project		Tettenhall Wood Institute, Wood Road	
subject		Proposed Ground and First Floor Plans	
scales	date	drawn by	dwg no
1:100	11 / 02 / 04	RJD	0076 / 11 F
		comp ref	
Civic Centre, St. Peter's Square, Wolverhampton. WV1 1RL.		Wolverhampton City Council Property Services	
Tel: (01902) 556556 Fax: (01902) 555403 EMail: wolverhampton.design@dial.pipex.com Copyright © Wolverhampton CC

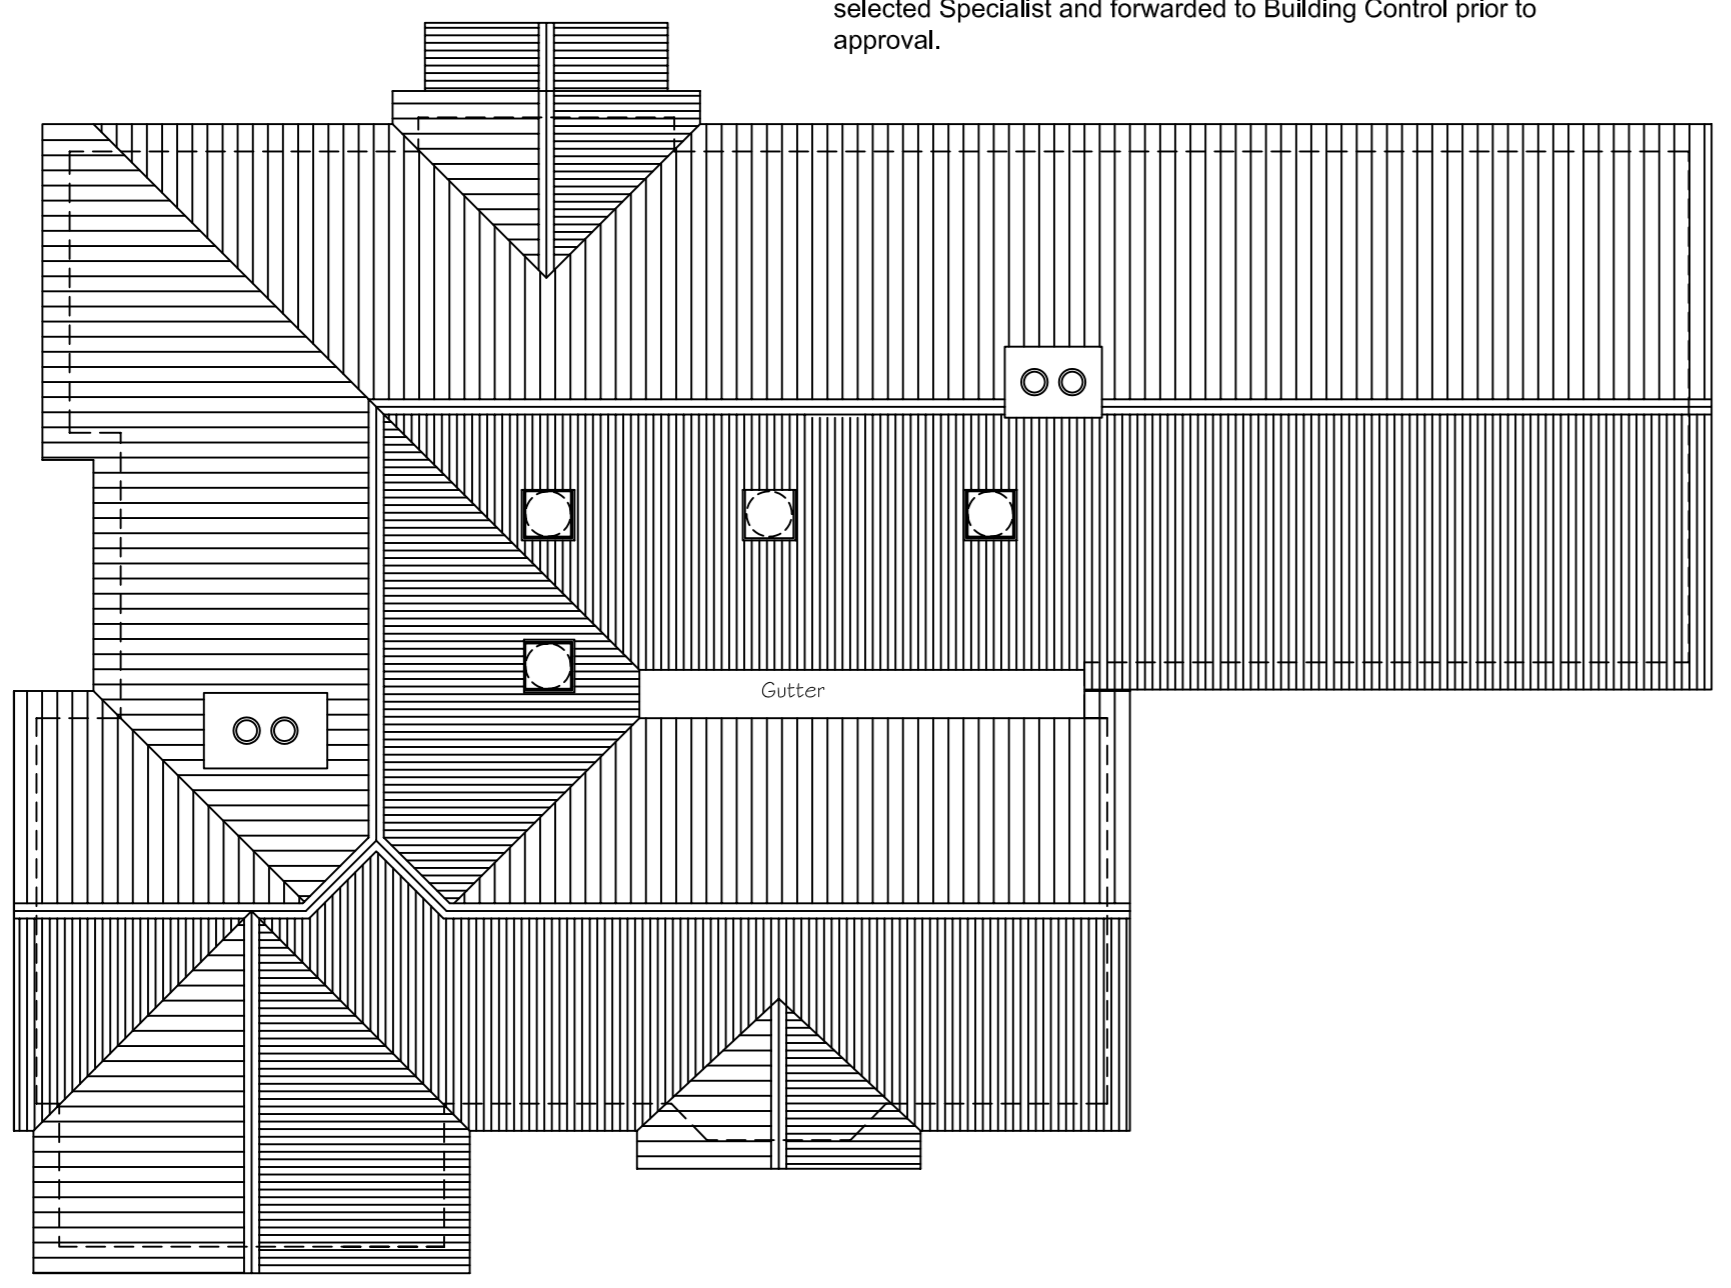
- F Flue to chimney adjusted to match structural calculations, note added. Kitchen layout added. Section line D - D added. Rooflight above main stairs removed. Door to Plant Room repositioned. Wall thickness amended to allow more insulation in cavity (note changes to room areas). RJD 17 / 06 / 04

- E Disabled Wc handed. Wall thickness reduced to suit cavity wall construction (room areas amended). Plant Room door amended to single leaf as requested. Room numbers, door numbers and window numbers added. Sunpipes added. Lift shaft amended. Pipe ducts to Kitchen added for water heater storage. RJD 07 / 06 / 04

- D Conservation Rooflights replaced with Sunpipes to provide natural light to circulation areas. Internal dimensions to rooms and brick dimensions added externally - please note some room areas may have been revised. Proposed Roof Plan added. RJD 23 / 03 / 04

- C Room 5 reduced in size to accomodate flue dimensions from Plant Room, window above Low Level Cupboard amended in size. RJD 11 / 03 / 04
- B Scheme revised as requested at meeting of 23 / 02 / 04. RJD 23 / 02 / 04

- A Scheme revised to meet Building Regulation fire escape requirements. RJD 20 / 02 / 04
